SYDNEY WESTERN CITY PLANNING PANEL

Panel Reference	2017SSW004
DA Number	1469/2016
Local Government Area	Camden
Proposed Development	Construction of two (2) x seven (7) storey residential flat buildings, containing 178 residential units and two (2) basement levels containing 221 carparking spaces, landscaping and associated works on proposed Lot 1 in a resubdivision of 28 Ingleburn Road.
Street Address	28 Ingleburn Road, Leppington
Applicant/Owner	Balintore Ingleburn Pty Ltd C/O Design Cubicle Pty Ltd Balintore Ingleburn Pty Ltd
Number of Submissions	Six (6) objections were received.
Recommendation	Refusal
Regional Development Criteria (Schedule 4A of the EP&A Act)	Capital investment value >\$20 million CIV - \$39,251,789
List of All Relevant s79C(1)(a) Matters	<ul style="list-style-type: none"> • State Environmental Planning Policy (State and Regional Development) 2011 • State Environmental Planning Policy (Sydney Region Growth Centres) 2006 • State Environmental Planning Policy No 55 – Remediation of Land • State Environmental Planning Policy No 65 – Design Quality of Residential Apartment Development • State Environmental Planning Policy (Building Sustainability Index: BASIX) 20

Image 2 – Current plan of three lot Torrens title subdivision and construction of roads as per DA / 1468/2016.

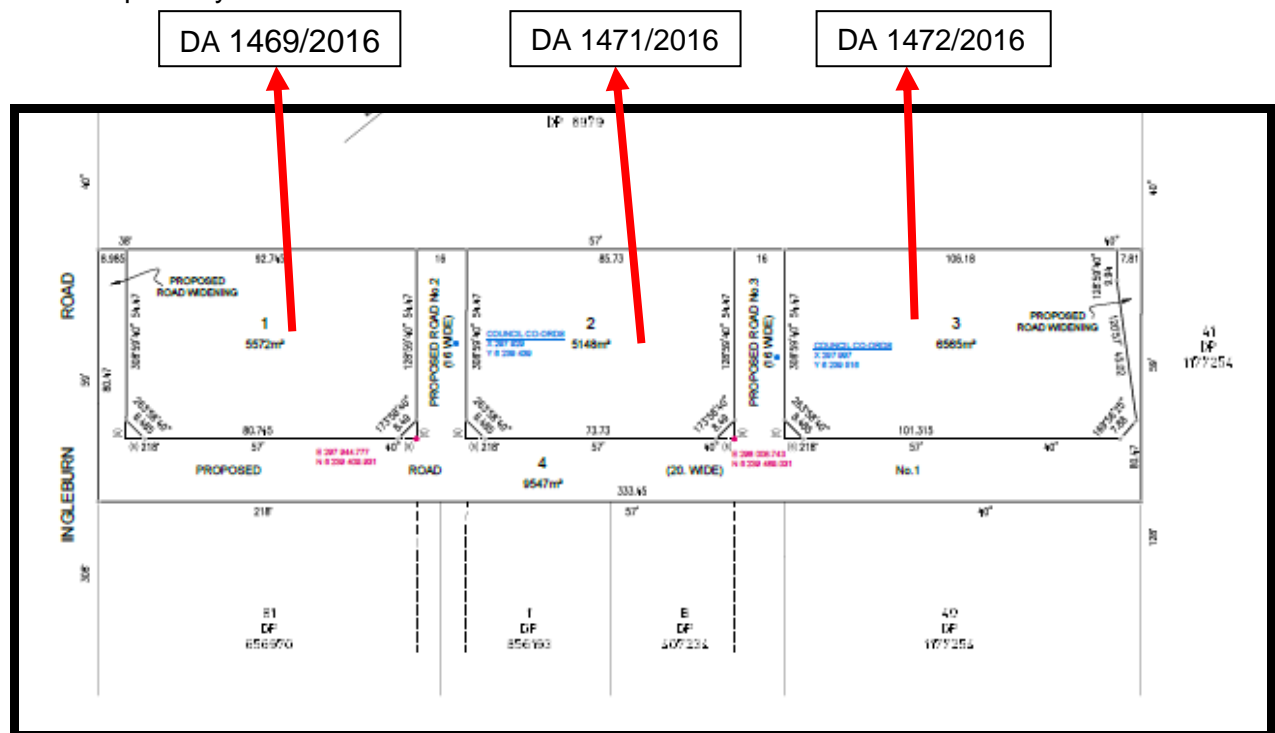
The location and alignment of proposed road no. 2, which runs east to west through the proposed subdivision and adjoining land was originally designed with an alternative location to that depicted on the indicative layout plan as per the Leppington Major Centres within a separate development application subject to DA 1468/2016. The alternative location affected the distribution of the road so that No. 1431 Camden Valley Way, Leppington was burdened with constructing approximately 12m of a 16m road, whilst the Indicative Layout Plan evenly distributed this road between No. 1423 and 1431 Camden Valley Way, Leppington.

Whilst the subdivision and road plans have been amended within DA 1468/2016 to correctly align proposed road No. 2 and 3 in accordance with the Indicative Layout Plan, the site and development plans for the residential flat building development subject to DA 1469/2016 have not been amended. Accordingly, the development is not consistent with the current plan of subdivision, which will ultimately form the lot and adjoining roads.

Image 3 – Proposed site plan

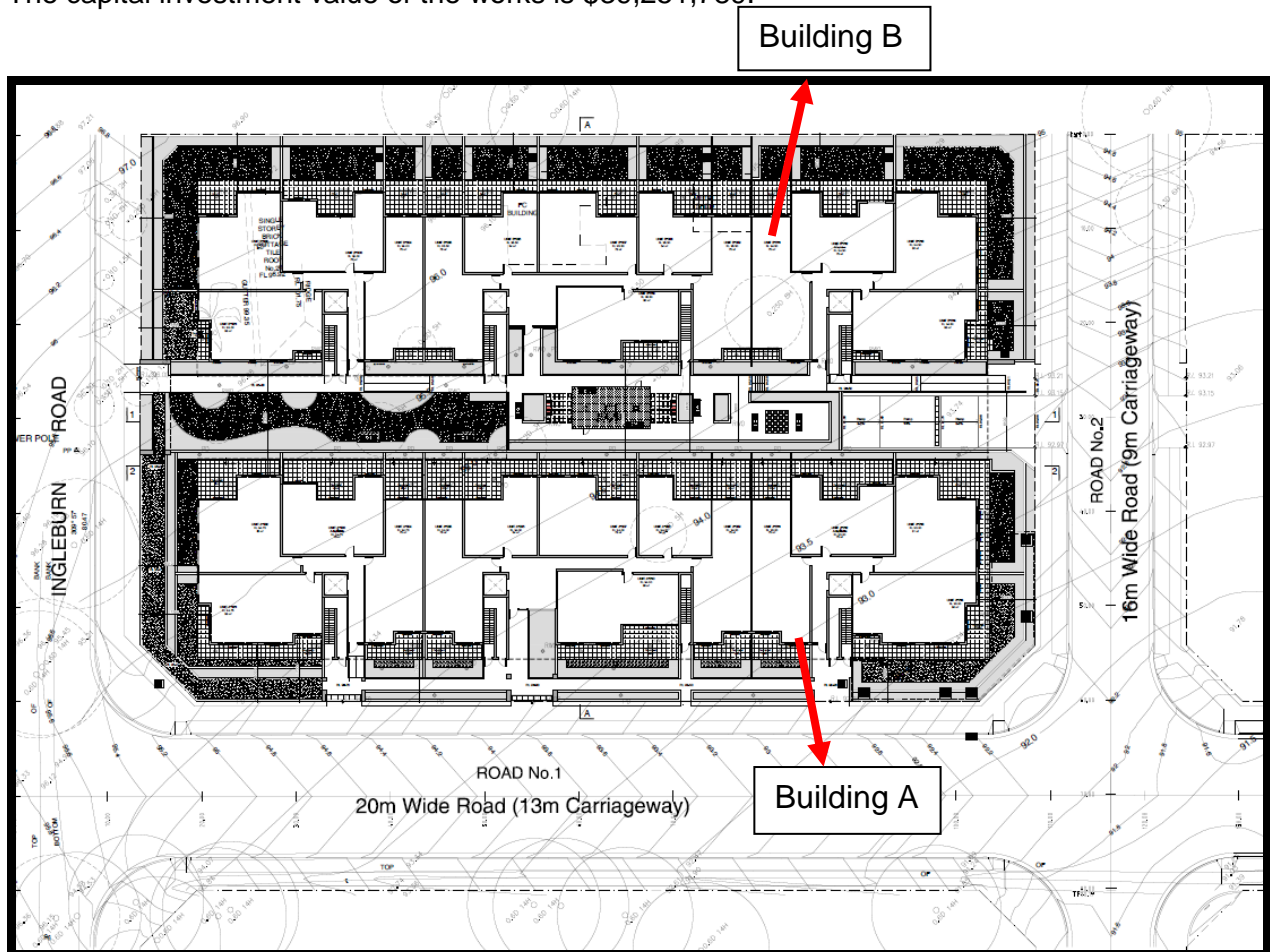
There are amenity impacts to adjoining residences and to proposed buildings on site through insufficient building separations and overshadowing, including overshadowing of future streets. In addition, the development fails to provide an adequate area of communal open space, which is extensively overshadowed throughout the day and which is also segregated from Building A through poor access.

The provision of deep soil area within the development is insufficient and does not comply with the ADG minimum dimension requirements of 6m. The insufficient deep soil area will not provide effective groundwater recharge area and enough space for vegetation to survive and thrive. The proposed deep soil area does not meet the objective stated in the ADG which requires to provide areas that allow for and support healthy plant and tree growth and to improve residential amenity.

The exposed basement ramp is considered to compromise the visual quality of the public domain and the ramp should be encapsulated into a built form. The basement ramp is also located on a northern aspect, eliminating the ability to utilize this area for communal open space with deep soil and benefitting from good solar access. Considering the overshadowing issue to the communal open space on the ground level, significantly improvements are required to enable solar amenity to be received to the ground floor communal open space to provide for better amenity and equitable access to all residents.

Image 6 – South west elevation (Ingleburn Road)

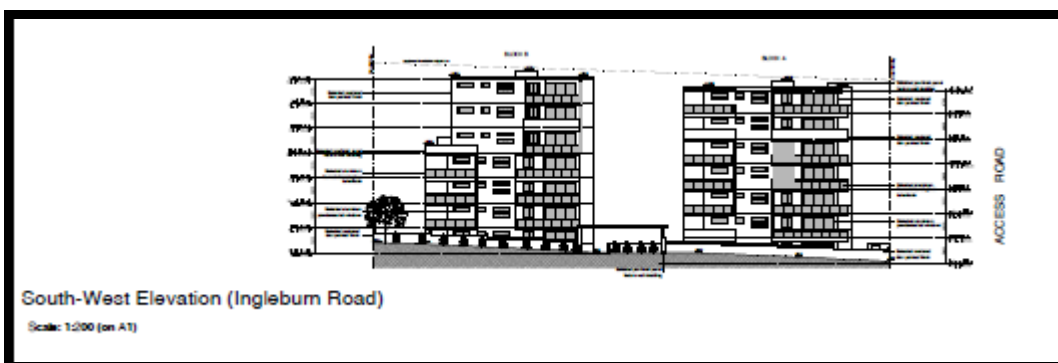
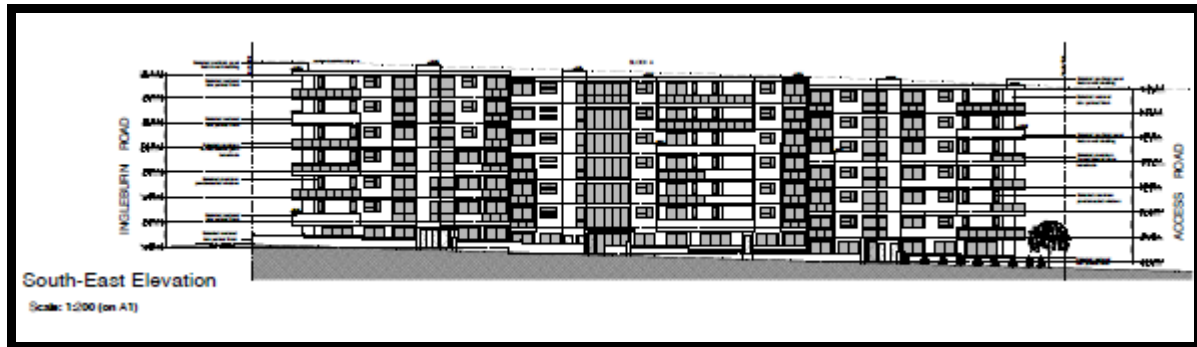
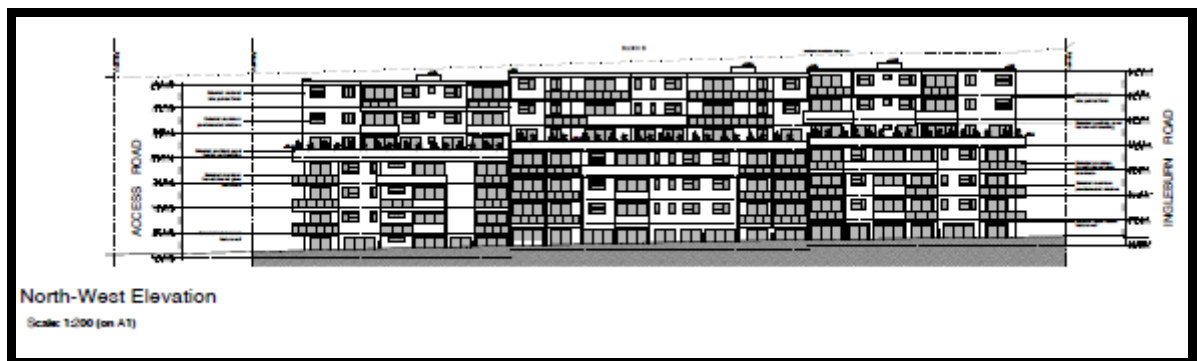
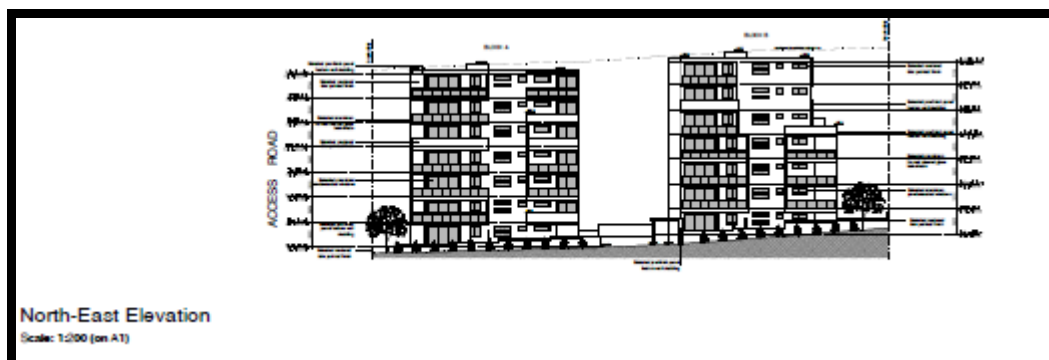
- The development does not satisfy the objective of Clause 4.3(1)(b) Height of buildings – *‘to minimise visual impact and protect the amenity of adjoining development and land in terms of solar access to the buildings and open space’*, as the proposed developments building length (greater than 80 metres) without significant breaks and articulation and continuous seven (7) storey streetwall is not an acceptable streetscape presentation and does not provide a ‘human scale’ streetscape or acceptable solar access impacts to neighbouring development;

- The development is reliant upon condensed floor to floor ceiling heights of 2.9 metres to reduce the developments height contrary to the requirements of the Apartment Design Guide (floor to floor minimum 3.1m) and Camden Growth Centre Precincts Development Control Plan (floor to finished ceiling height). With complying floor to floor heights, the development would exceed the maximum height by up to 1.5 metres;

The entire area is undergoing a significant transition from rural/rural residential, to an urban character. In consideration of the proposed built form and establishing the future character of Leppington, building height and length coupled with street wall height are essential to create a desired streetscape. The proposed building length (over 80m) is considered excessive. An appropriate built form would provide breaks in the façade with indents and recesses every 20m and discontinuing the length of the building every 30 – 40m. In this instance, the proposed buildings with 80m or more building length would require to be broken at least into two separate buildings with effective articulation on the facades to mitigate the perception of bulk and scale.

In addition, the proposed continuous seven (7) storey street wall proposed along the 20m residential collector road is a not an acceptable built form for the subject site and the desired future streetscape as it does not provide a ‘ human scale ’ to the development. A two (2) to four (4) storey wall height across the site, with a secondary setback above the podium without any protrusions would allow a pedestrian-friendly streetscape and reduce overshadowing to adjoining streets and lots.

As discussed in the above Principle 1, the proposed building length (Greater than 80m) is excessive and needs to be broken up to a maximum of 30m to 40m to create an adequate urban design / form response to present a more relevant human scale to the street and to ensure the amenity of future developments.

The proposed buildings lack articulation on all of the facades. In addition, the proposed development does not adopt quality materials to vary the finishes to create architectural interest, which is heavily reliant on the use of painted render. The development fails to provide a secondary setback into the design to provide breaks between the street wall height and the upper levels. Vertical elements and proper insets are also required to create breaks on the proposed facades every 20m to create visual interest to the facades of the development.
